**ZONING AMENDMENT &
SUBDIVISION STAFF REPORT****Date: December 2, 2004****NAME**

LOCATION4175 Halls Mill Road
(East side of Halls Mill Road, 930'± North of Alden Drive)**CITY COUNCIL
DISTRICT**

The applicant is requesting rezoning from R-1, Single-Family Residential to B-3, Community Business for a lounge, as well as subdivision approval to create two legal lots of record.

SITE PLAN

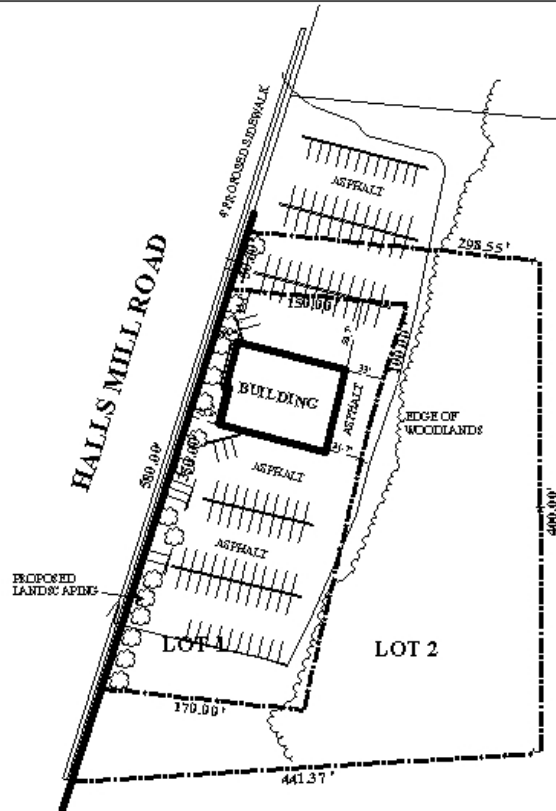
Driveway number, size, location, and design to be approved by Traffic Engineering and conform to AASHTO standards. Typical driveway widths are twenty-four feet. Changes should be made to the existing driveway to allow for a single driveway opening of a more appropriate width than the one shown. The current opening will create multiply conflict points along Halls Mill Road and in the parking lot. Parking which backs into the right-of-way should be eliminated as well as the angled parking next to the building. Parking aisles should be a minimum of twenty-four feet.

Although the proposed rezoning would be considered compatible with the surrounding area, there are elements of the site plan that must be addressed. First, as illustrated in the Traffic Engineering Comments, the parking lot configuration is somewhat haphazard; therefore, full compliance with the Traffic Engineering Comments should be required.

Additionally, the parking area extends across Lot 2 and onto the adjacent property to the North, which is zoned R-1, Single-Family Residential. While the two individuals that own this site also own the remaining R-1 parcels on the East side of Halls Mill Road, those properties are still zoned residentially, thus no commercial improvements, including parking, would be allowed. Any nonconforming status they may have enjoyed has expired, thus all parking must be removed from the residential properties. Moreover, if a portion of the parking area for business on Lot 1 remains on Lot 2, the submission and approval of a Planned Unit Development application would be required for shared parking and access.

Rezoning Based upon the preceding, this application is recommended for approval subject to the following conditions: 1) that the parking layout be modified, including the removal of all existing parking on residentially zoned properties, in compliance with the parking requirements of the Zoning Ordinance as outlined in Section VI; 2) full compliance with the Traffic Engineering Comments (driveway number, size, location, and design to be approved by Traffic Engineering and conform to AASHTO standards; changes should be made to the existing driveway to allow for a single driveway opening of a more appropriate width than the one shown, parking which backs into the right-of-way to be eliminated as well as the angled parking next to the building; two-way parking aisles to be a minimum of twenty-four feet in width); 3) the submission and approval of a Planned Unit Development application for any shared parking, access and maneuvering between Lots 1 and 2; 4) full compliance with the landscaping and tree planting requirements of the Ordinance; 5) the provision of a buffer, in compliance with Section IV.D.1., where the site adjoins residential zoning, when and if the adjoining property is developed residentially; and 6) full compliance with all municipal codes and ordinances.

Subdivision With modifications the plat will meet the minimum requirements of the Subdivision Regulations and is recommended for Tentative Approval subject to the following conditions: 1) dedication of any necessary right-of-way to provide 35-feet from the centerline of Halls Mill Road, a collector street; and 2) that the number, location and design of all curb cuts be approved by Traffic Engineering.
